Our Reference: DB 12-148A

Re: Panel Ref: 2015SYE018 Development Application No 2015.08.1 for land at 137 Victoria Street Ashfield - Cardinal Freeman Village – Proposed Conditions of Consent – Meeting of 13 August 2015.

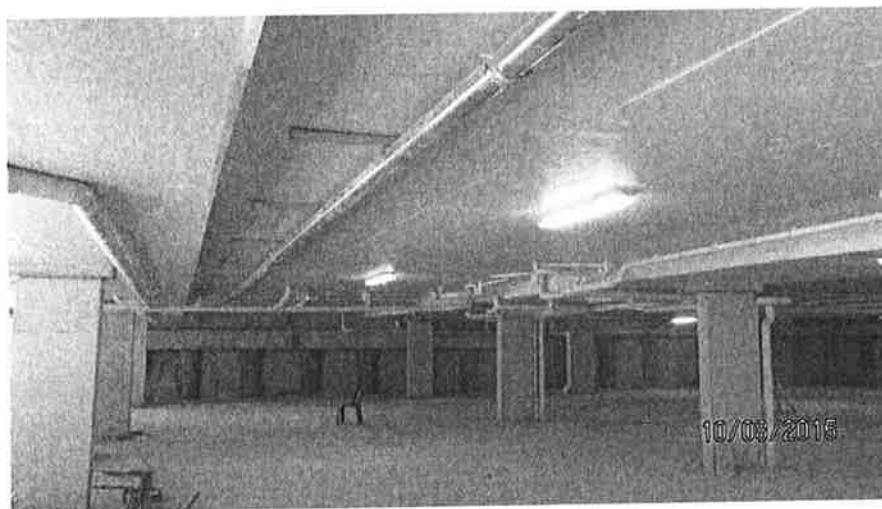
2. CONDITION A(4)(H) BASEMENT PAINTED WHITE

It is considered impractical for the walls of the basement to be painted where there are wet walls with exposed piles as per the photo below:

However the ceilings will be finished in white and the illumination would achieve the lux level required by condition C(5) (see following photo).

It is suggested that this condition be amended to read:

- h) Basement car park ~~walls~~ **ceilings** to be ~~painted~~ **finished** in white to increase lux levels and light reflection, aiding in the illumination of the area.*
